**City of Portland, Maine - Building or Use Permit Application**

Permit No: 06-0311	Issue Date: <b>PERMIT ISSUED</b> APR - 7 2006	CBL: 047, C012001
-----------------------	---	----------------------

<b>Proposed Use:</b> 3 unit residential/ interior modifications to enlarge owner occupied first floor unit by expanding into the back of the second floor unit	<b>Proposed Project Description:</b> interior modifications to enlarge owner occupied first floor unit by expanding into the back of the second floor unit
---	---

**Dept:** Building      **Status:** Approved with Conditions      **Reviewer:** Mike Nugent      **Approval Date:** 03/31/2006

Top view

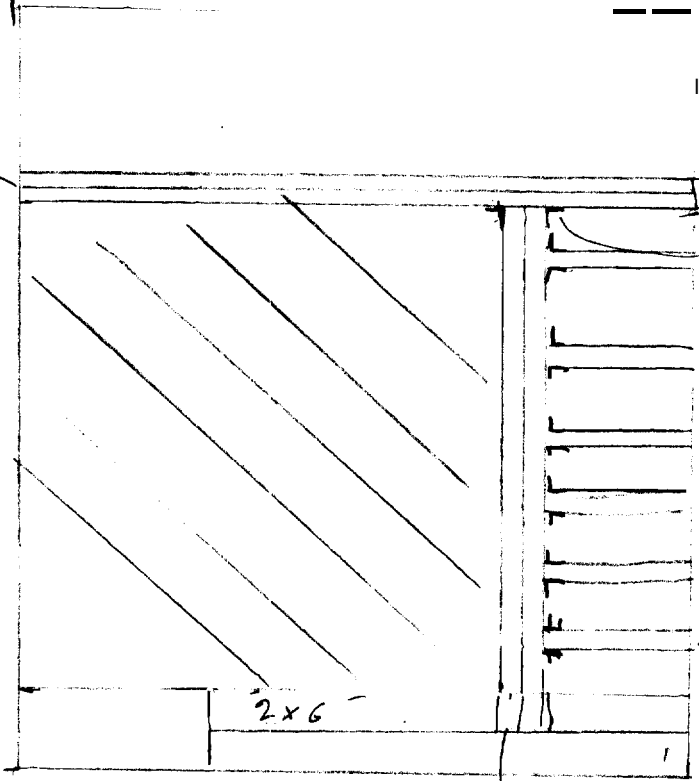
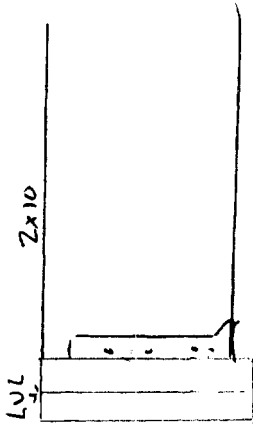
Handrails/guards along the stairs must be graspable and 34 to 38 inches in height as measured from the leading nose of the tread, with openings less than 4 inches
- 3) The proposed LVL support on existing masonry must be done to protect the LVL from deterioration in accordance with the manufacturer's specs, this information must be provided prior to framing.
- 4) All of these conditions were discussed with and agreed upon by Snow Builders.
